RE: Response to IDNR Letter dated January 24, 2025 (Doc #111960)
Conceptual Development Plan
Marshall County Sanitary Landfill
Permit No. 64-SDP-02-75P

This letter contains responses and information requested in the January 24, 2025 IDNR letter related to IDNR review of the Conceptual Development Plan (CDP, Doc #111541) for the Marshall County SLF. Our responses are formatted according to the numbered items in the referenced letter (Doc #111960).

* EXISTING

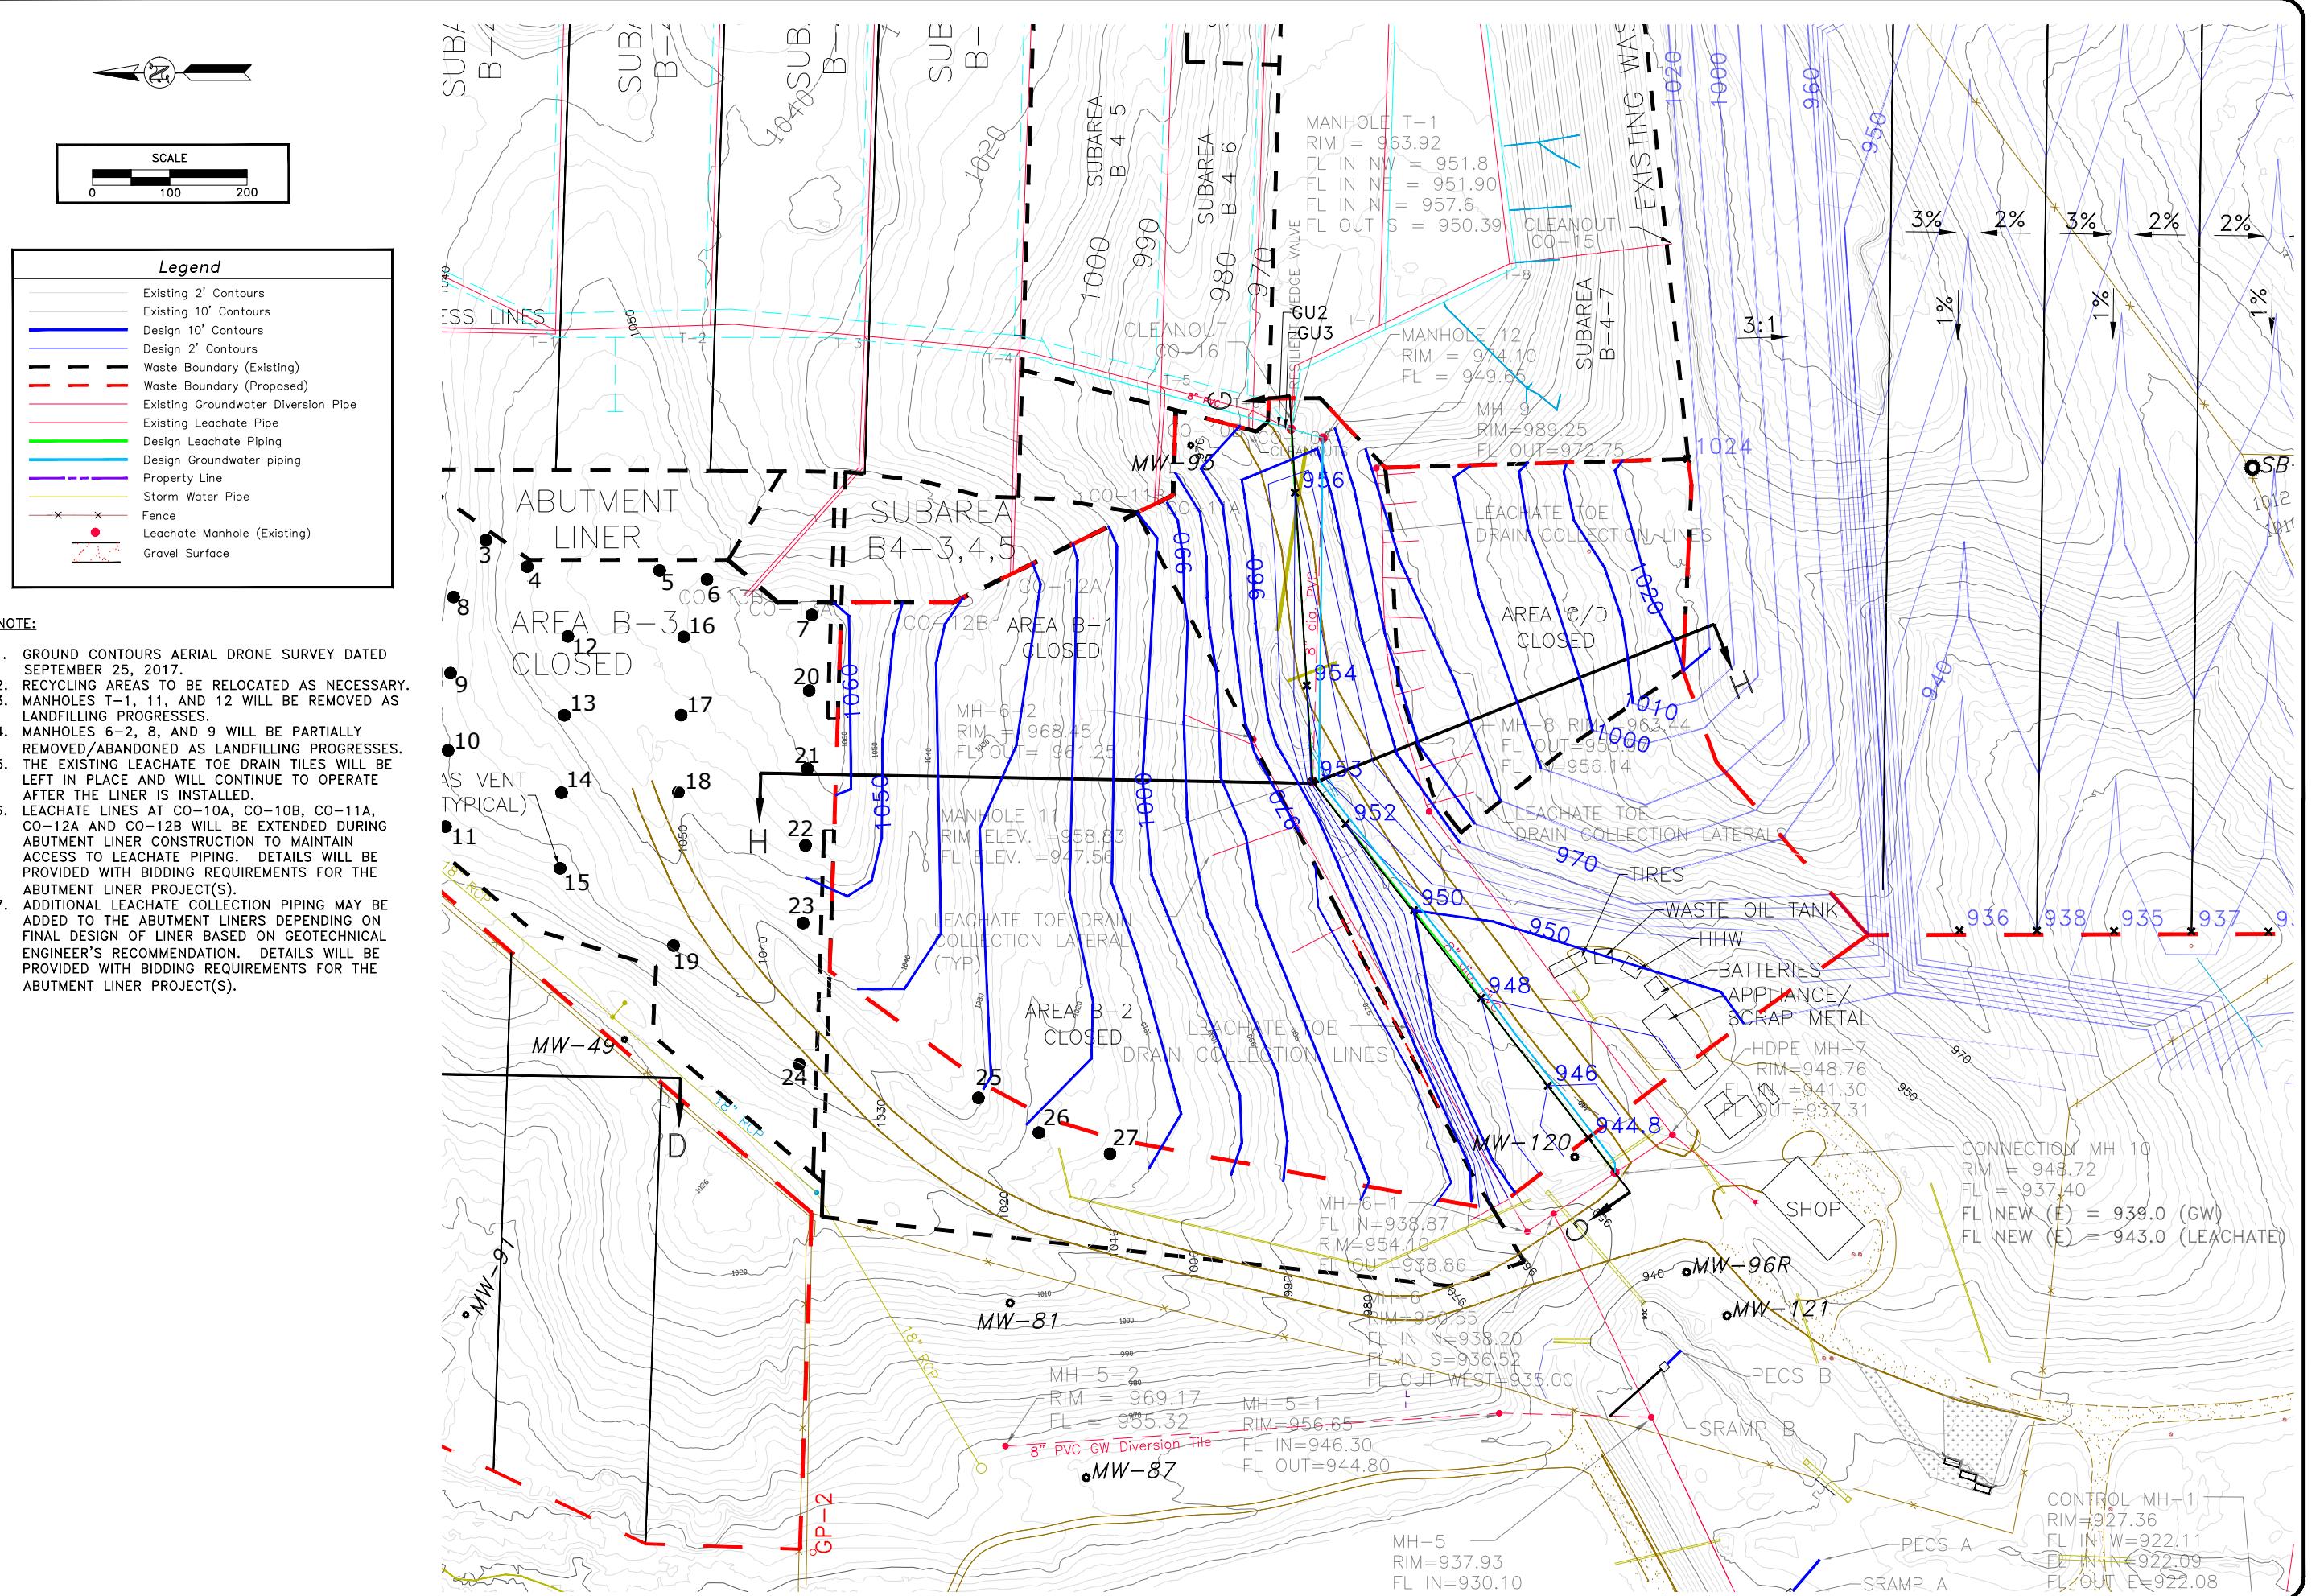
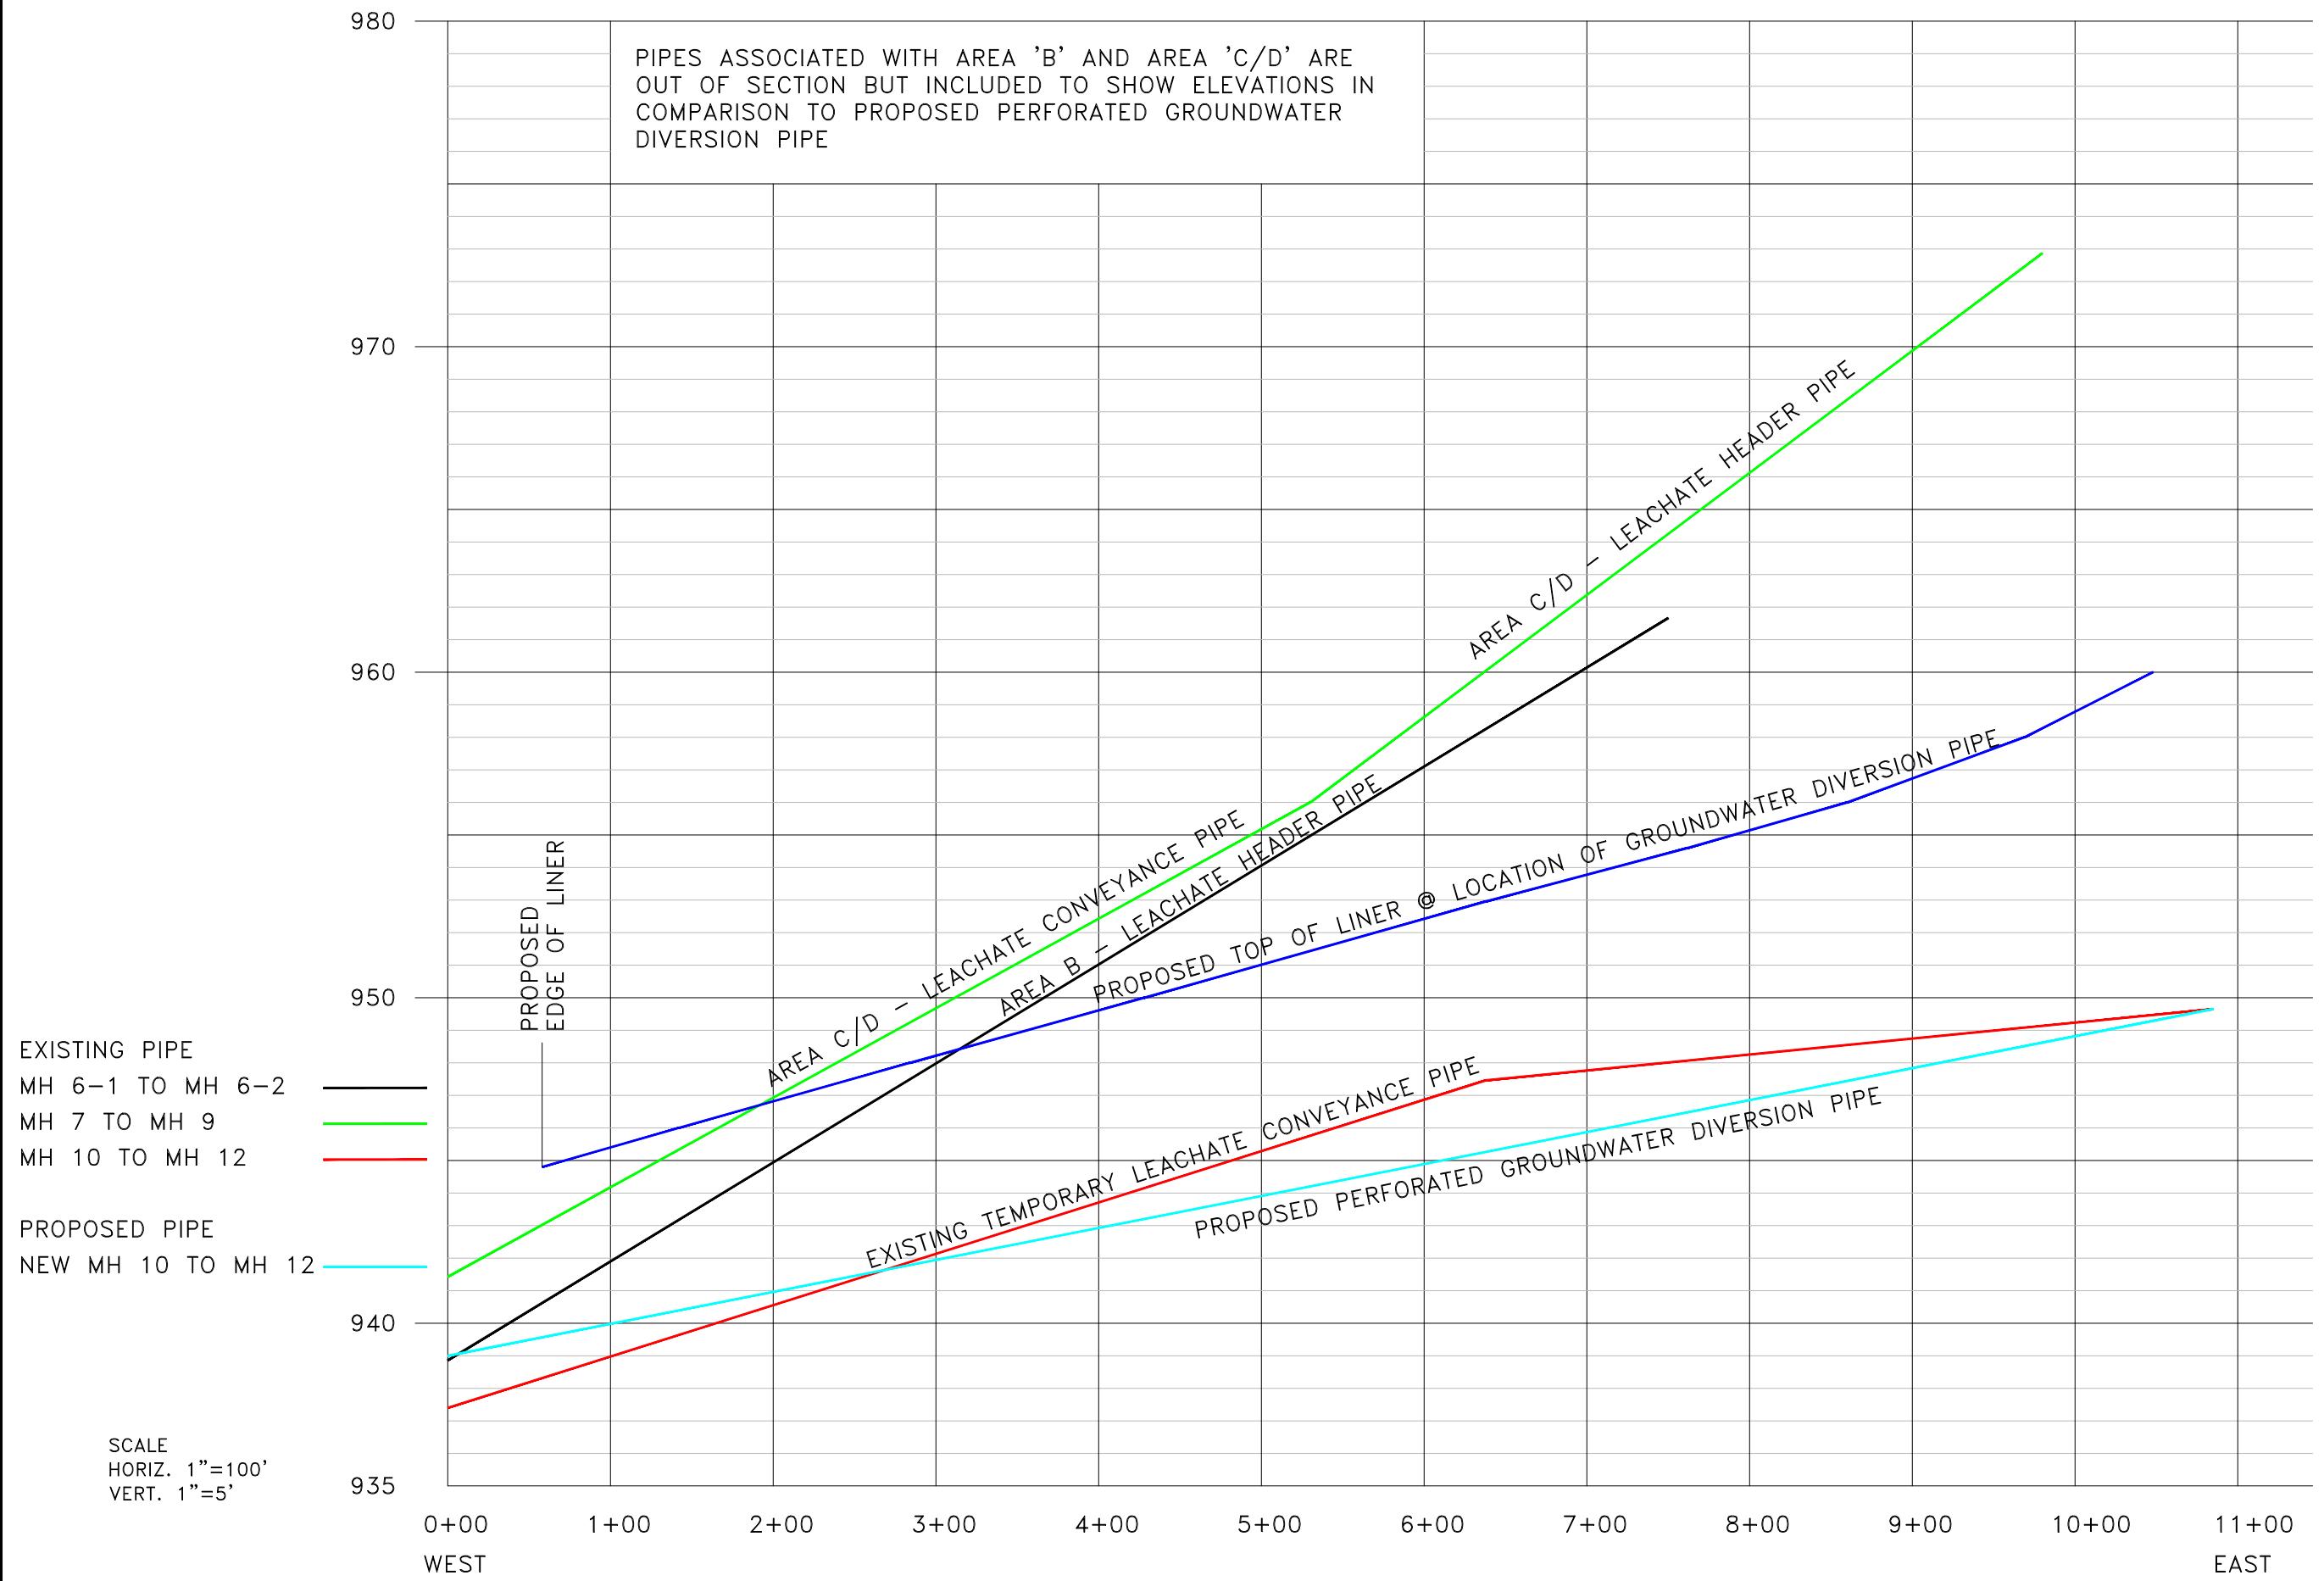
Groundwater diversion piping will be installed on the base of the future disposal areas parallel to the leachate collection piping. The proposed location of the groundwater diversion piping in each

area is shown on revised Figures 6, 7 (South Development Plan), 10 (North Development Plan), and 15 (Mid Area Development Plan) in Attachment A.

The elevations of the manholes and leachate conveyance piping for the North Development Area (except for MH NE-8 and MH NE-9) have been lowered by approximately 6' from the elevations shown in the CDP to allow the groundwater collected in the attenuation zone shown in the "2019 Amendment #1 to the 2017 Assessment of Corrective Measures Report" (Doc #95276) to either be routed to the leachate collection system and conveyed to the leachate storage lagoons (as shown on Figure10) or, if future testing warrants, to be discharged to the surface. MH NE-8 and MH NE-9 were not lowered as the groundwater collected in areas that drain to these manholes is outside of the attenuation zone. Construction in the North Development Area will proceed from south to north so these two manholes could be modified prior to construction to allow the groundwater piping to be connected to the leachate collection system at these manholes if deemed necessary by future water quality testing.

20

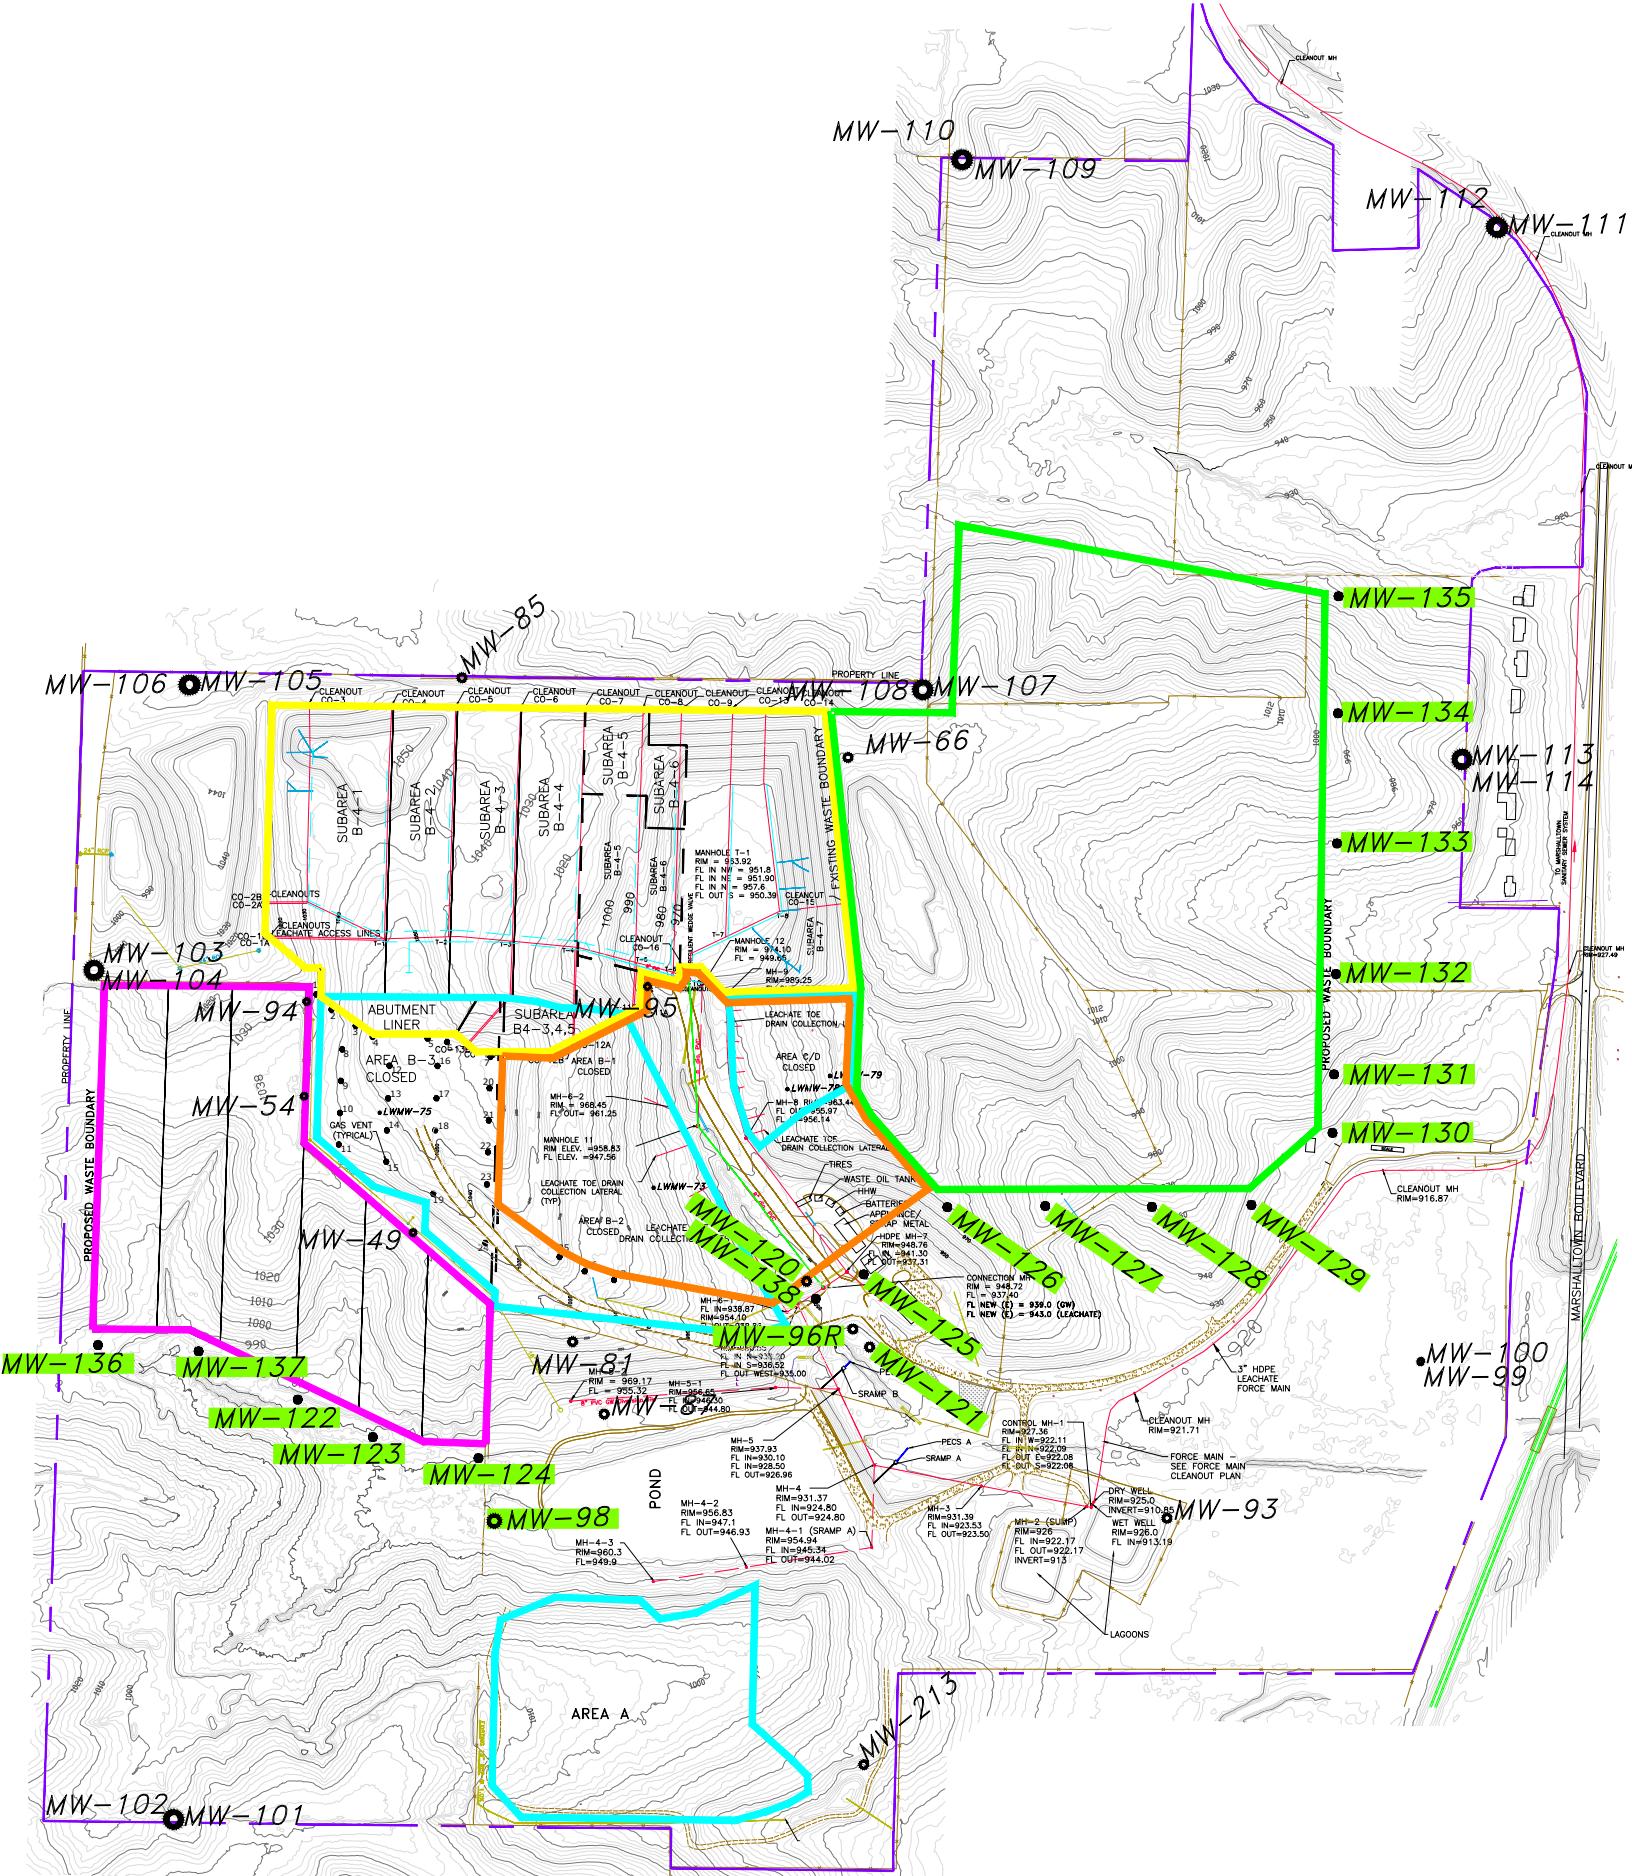
Rewvisions to the location of future monitoring wells are made and are illustrated on revised Figure 20 (included in Attachment C) of the December 20, 2024 Hydrologic Monitoring System Plan (HMSP) included in Attachment E of the CDP (Doc #111541).

MW-124 was moved to the southwest corner of the North Development Area. The remaining wells along the downgradient edge (MW-122 and MW-123) were shifted south accordingly. There are two (2) additional monitoring wells (MW-136 and MW-137) illustrated along the remaining downgradient edge to satisfied the 300 ft spacing requirement of 113.10(2)"e"(2).

MW-138 has been added to revised Figure 20 on the north side of the central drainage channel of the Mid Area Development.
